RS-02-196

LaSalle County Station, Units 1 and 2  
Facility Operating License Nos. NPF-11 and NPF-18  
NRC Docket Nos. 50-373 and 50-374

**Subject:** Revised Request for Amendment to Technical Specifications  
Justification for the Continued Use of Technical Specifications, Section  
3.4.11, "RCS Pressure and Temperature (P/T) Limits"

Figure 3.4.11-1 (Page 1 of 1)

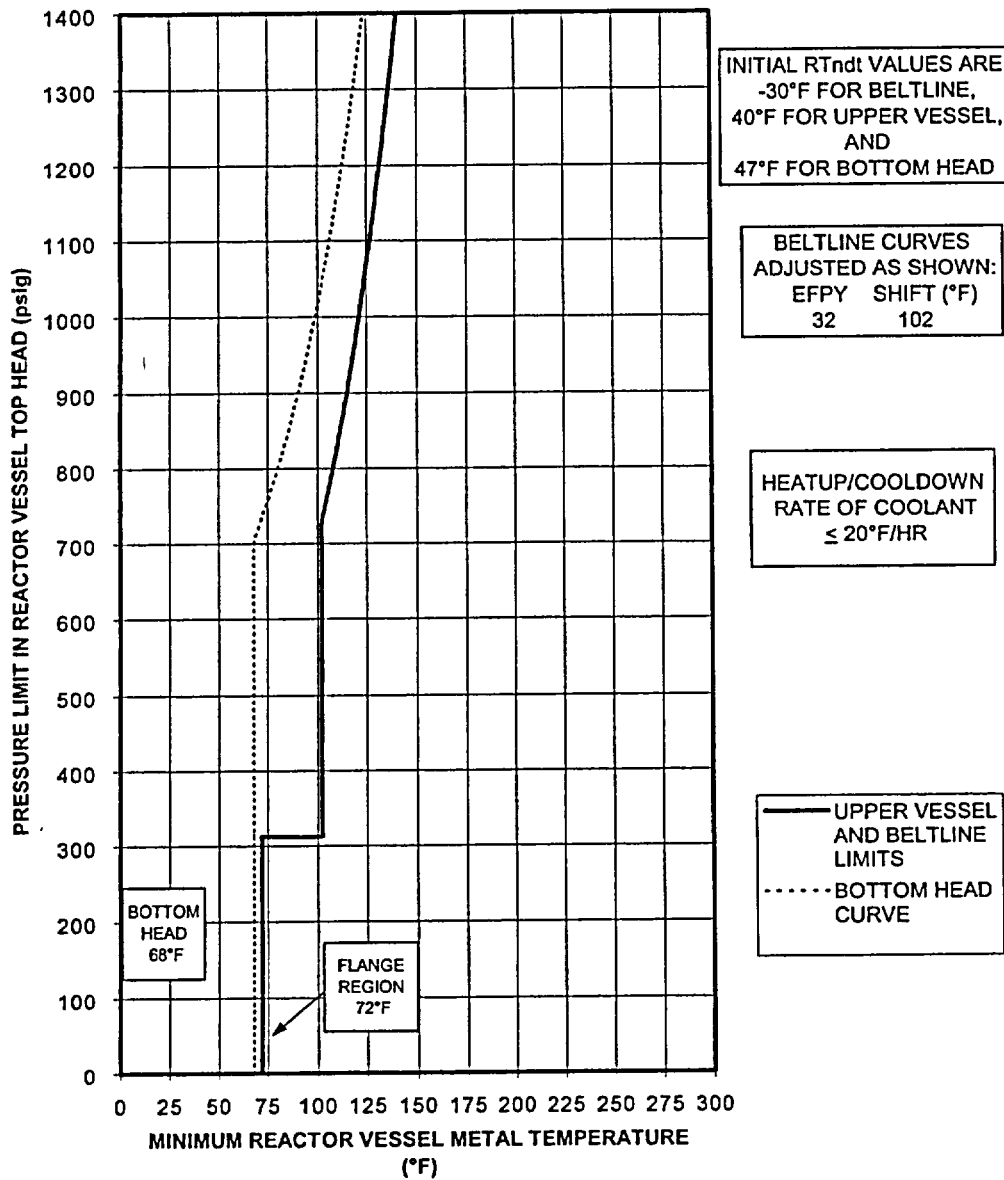
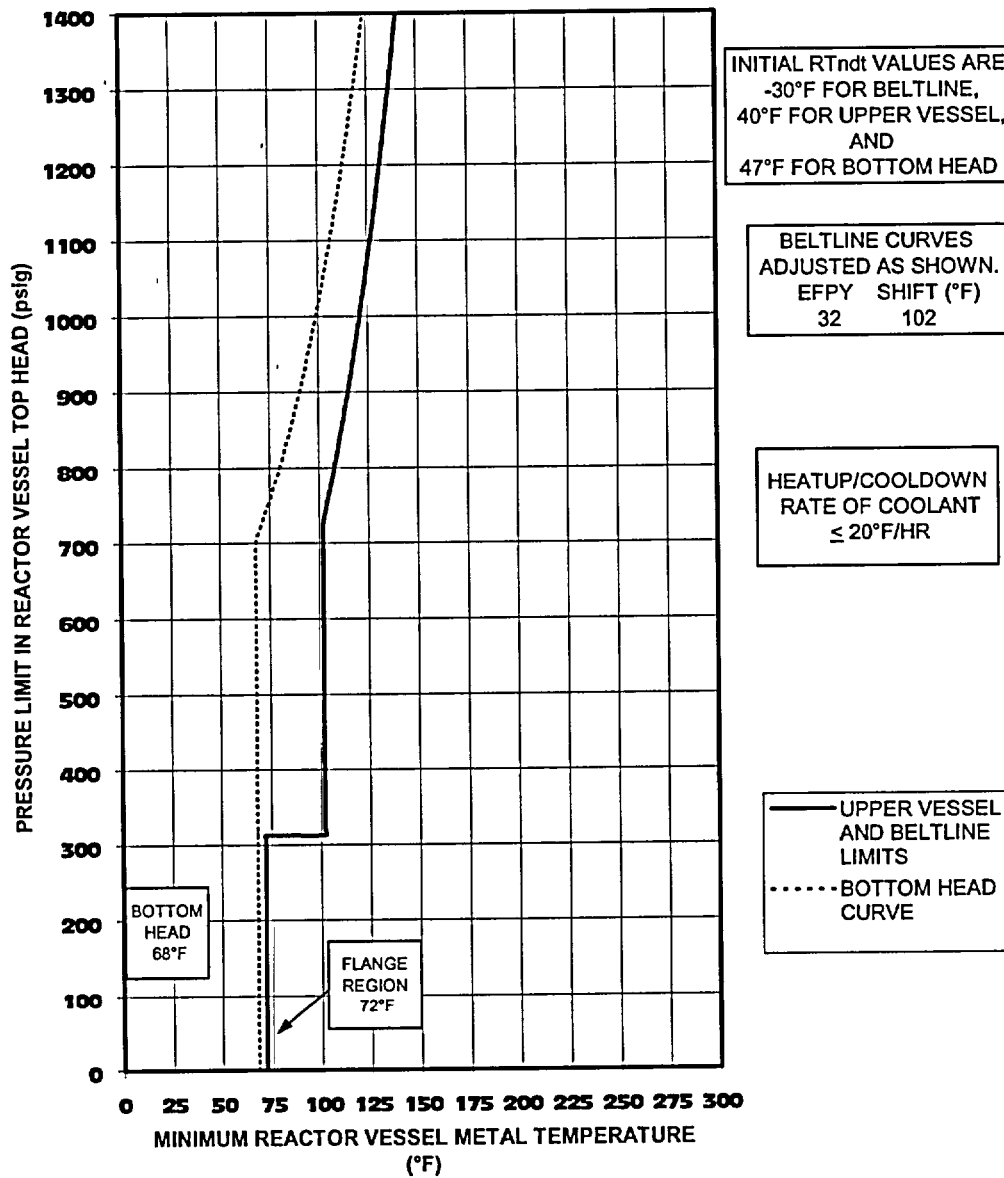
The proposed change requests that the current LSCS, Units 1 and 2, P/T limit curves in TS 3.4.11 remain acceptable for use until December 15, 2004. TS Figures 3.4.11-1 through Figure 3.4.11-6 are revised to indicate the December 15, 2004 applicability.

Unit 1  
Minimum Reactor Vessel Metal Temperature vs.  
Reactor Vessel Pressure (Valid up to 32 EPFY)

Unit 1  
Minimum Reactor Vessel Metal Temperature vs.  
Reactor Vessel Pressure (Valid until December 15, 2004)

Figure 3.4.11-2 (Page 1 of 1)

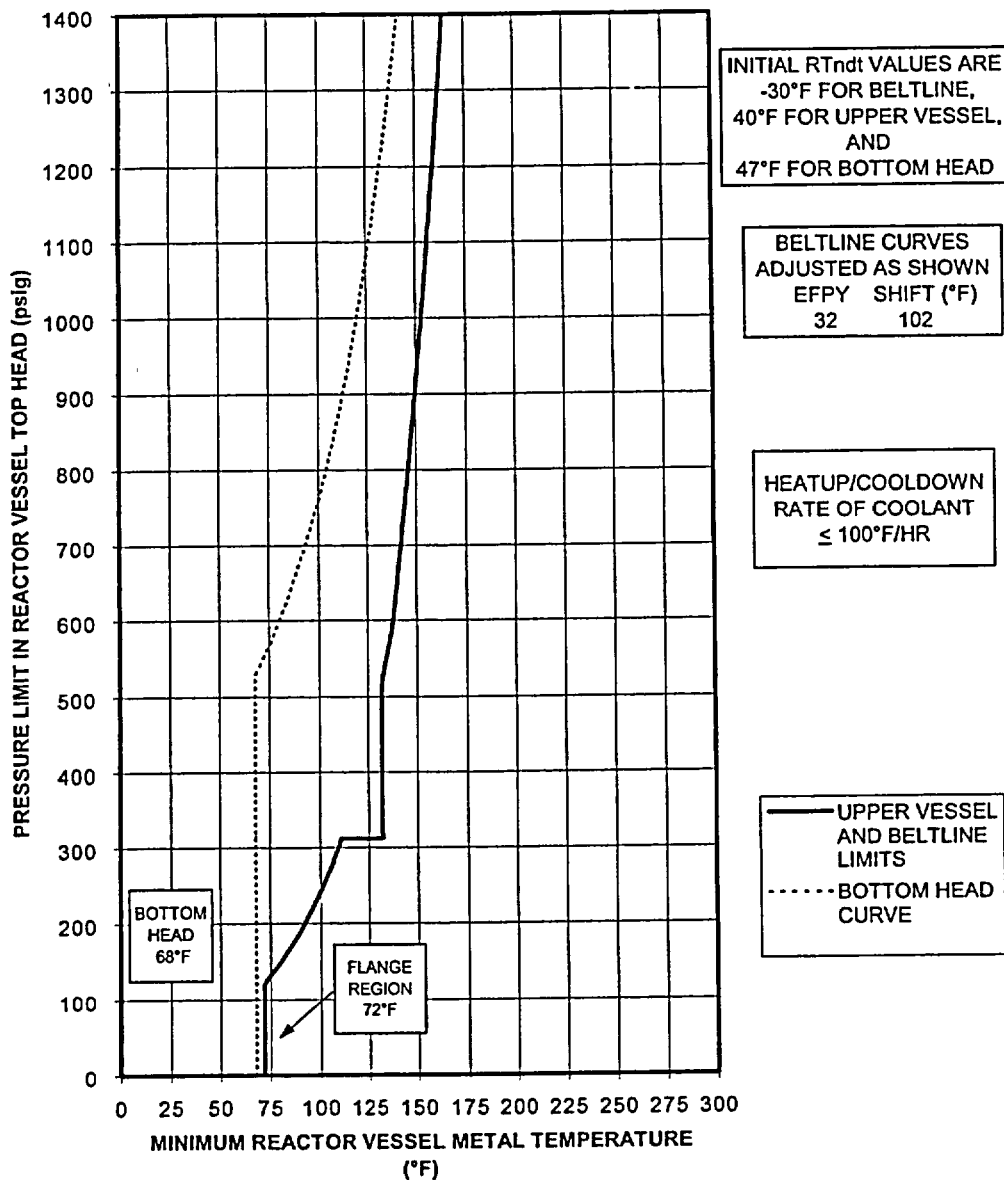
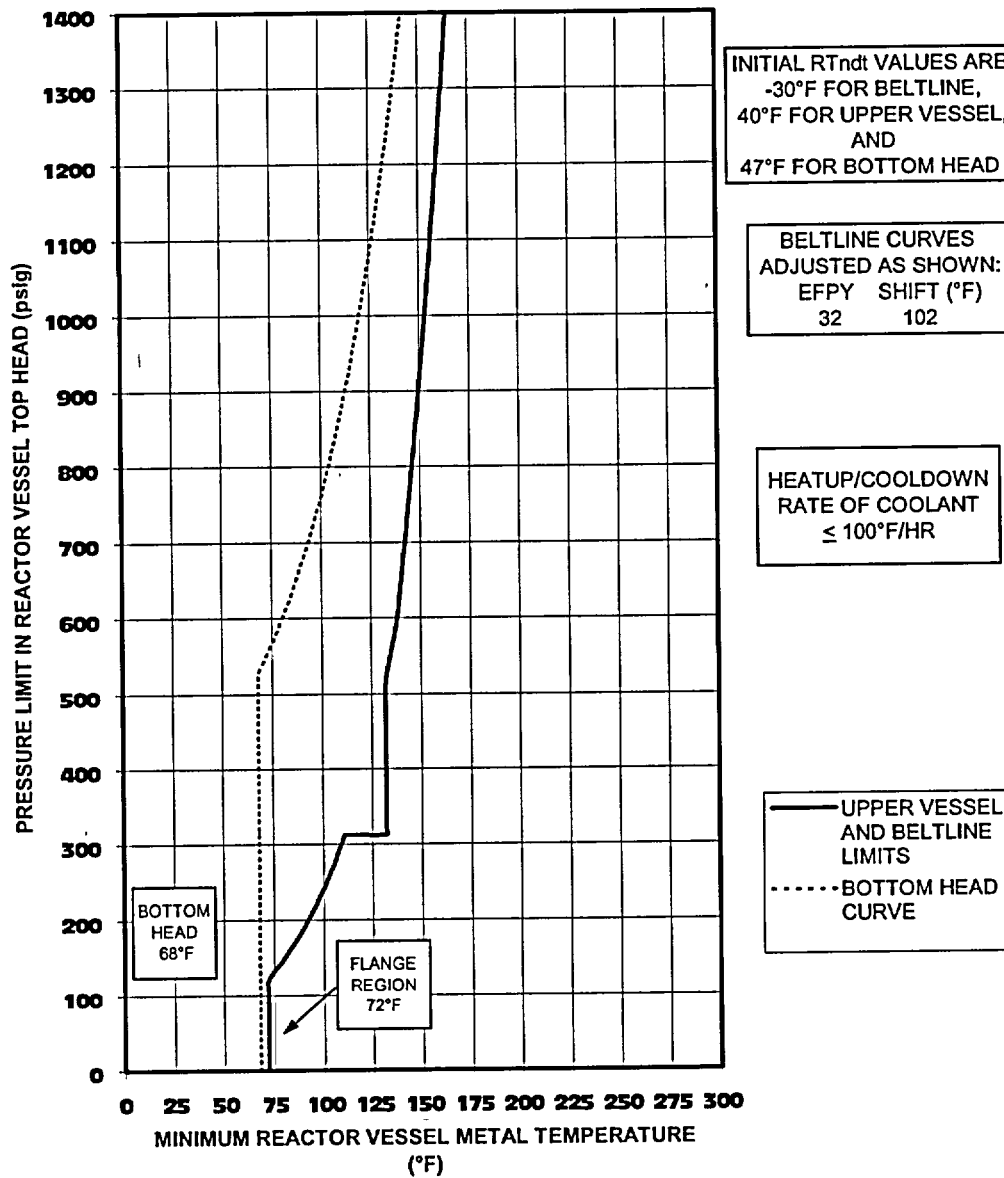
UNTIL DECEMBER 15, 2004

Unit 1  
Minimum Reactor Vessel Metal Temperature vs.  
Reactor Vessel Pressure (Valid up to 32 EPFY)

Unit 1  
Minimum Reactor Vessel Metal Temperature vs.  
Reactor Vessel Pressure (Valid until December 15, 2004)

Figure 3.4.11-3 (Page 1 of 1)

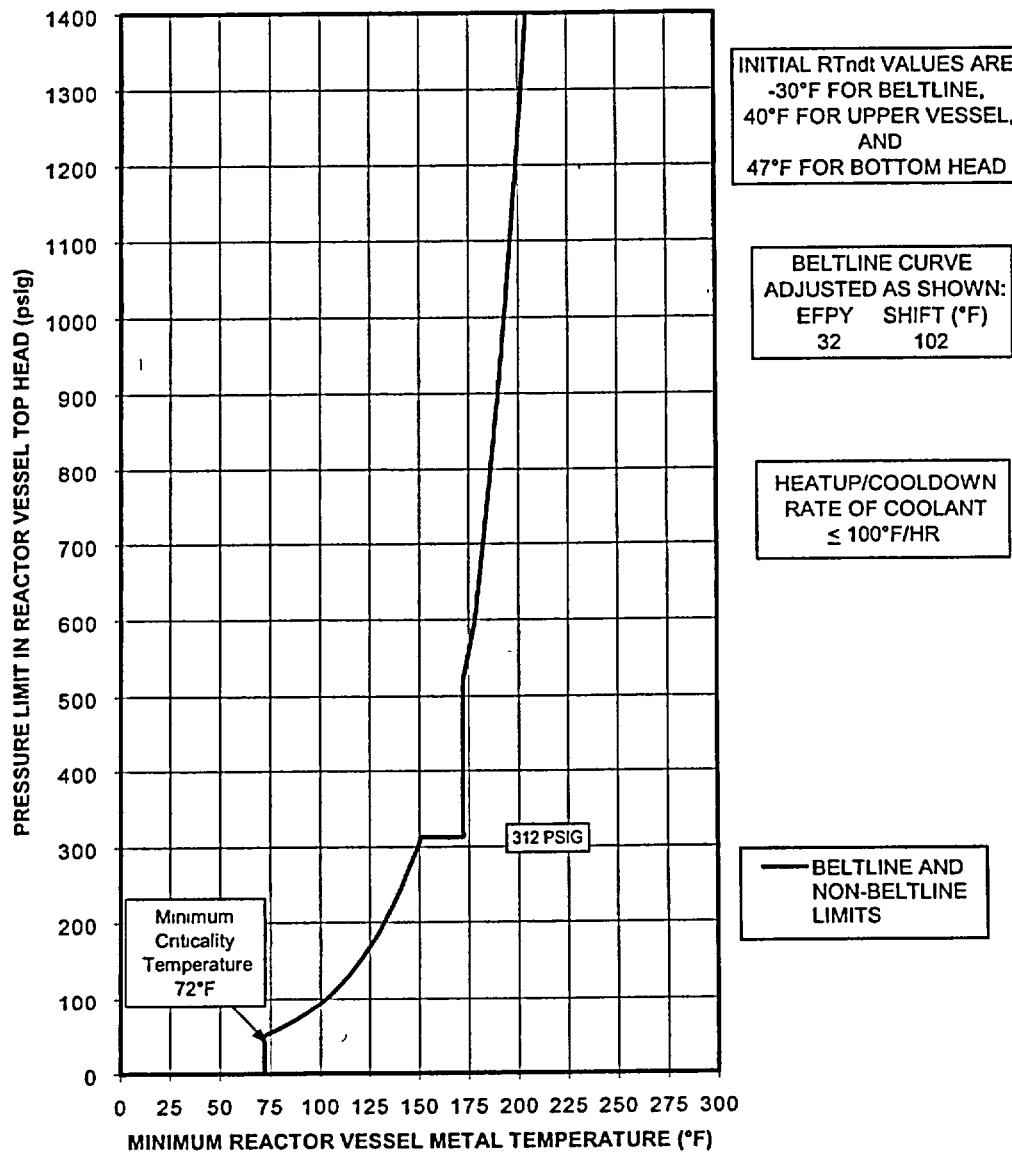
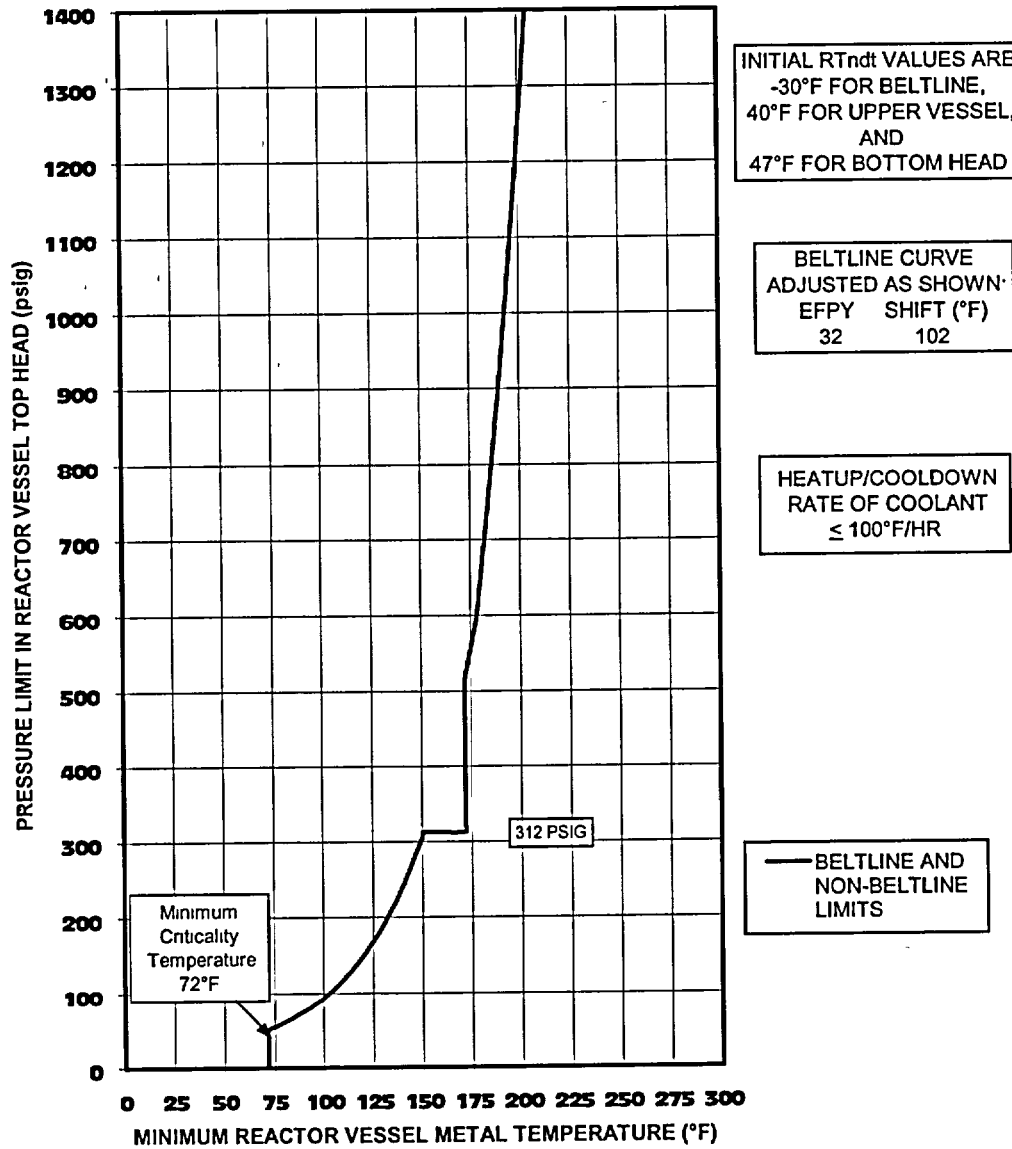
UNTIL DECEMBER 15, 2004

Unit 1  
Minimum Reactor Vessel Metal Temperature vs.  
Reactor Vessel Pressure (Valid up to 32 EFPY)

Unit 1  
Minimum Reactor Vessel Metal Temperature vs.  
Reactor Vessel Pressure (Valid until December 15, 2004)

Figure 3.4.11-4 (Page 1 of 1)

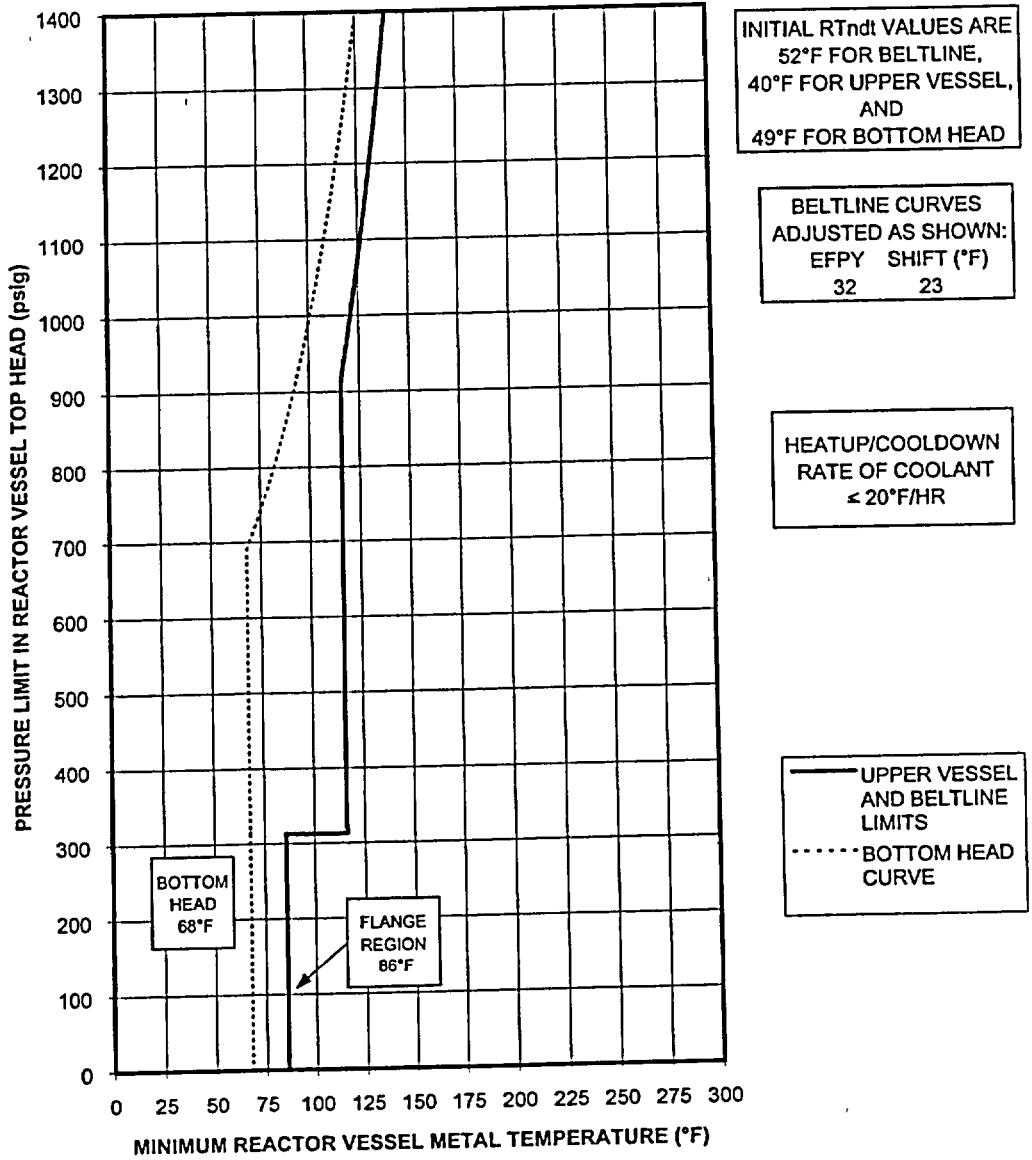
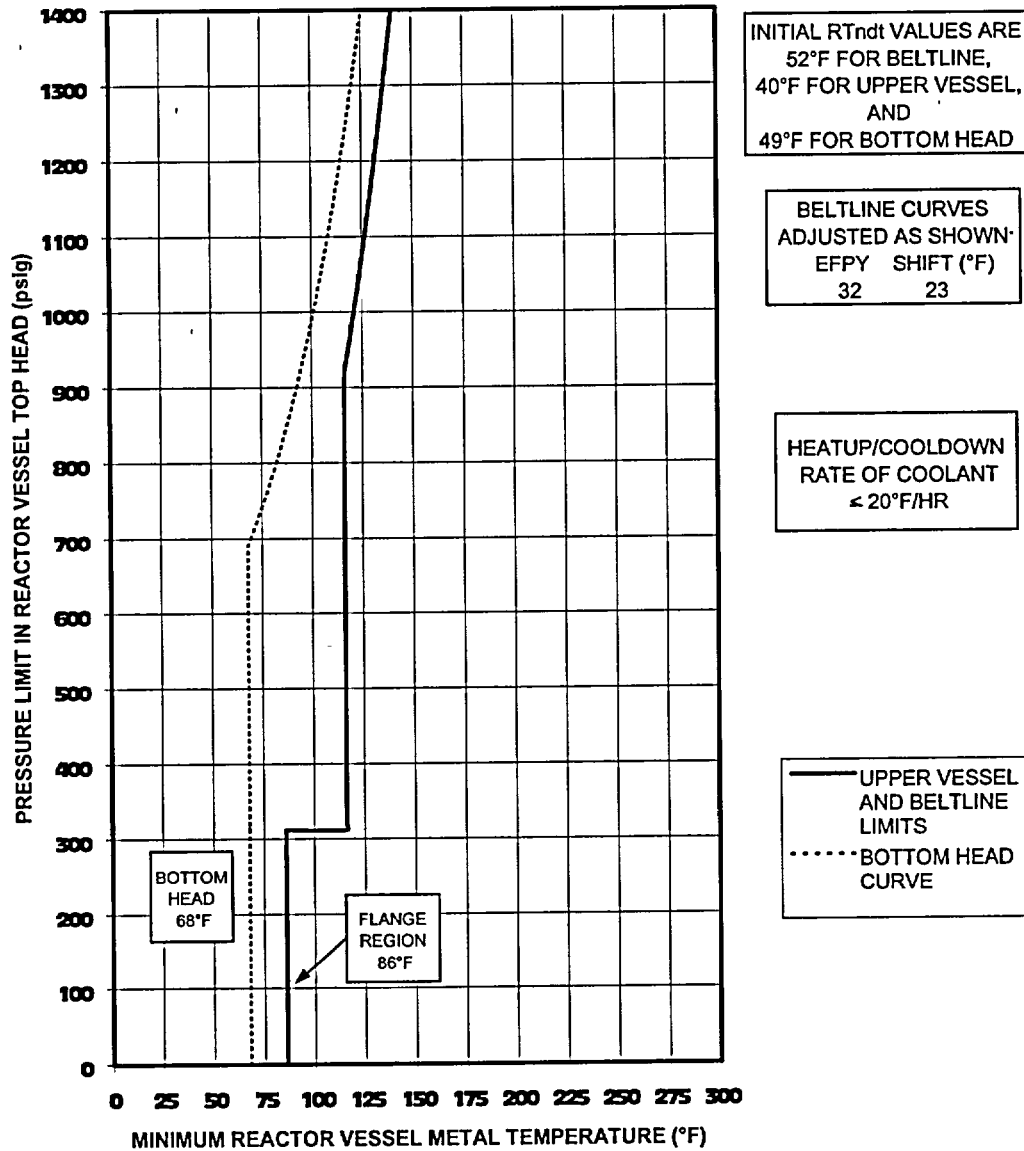
UNTIL DECEMBER 15, 2004

Unit 2  
Minimum Reactor Vessel Metal Temperature vs.  
Reactor Vessel Pressure (Valid up to 32 EFPY)

Unit 2  
Minimum Reactor Vessel Metal Temperature vs.  
Reactor Vessel Pressure (Valid until December 15, 2004)
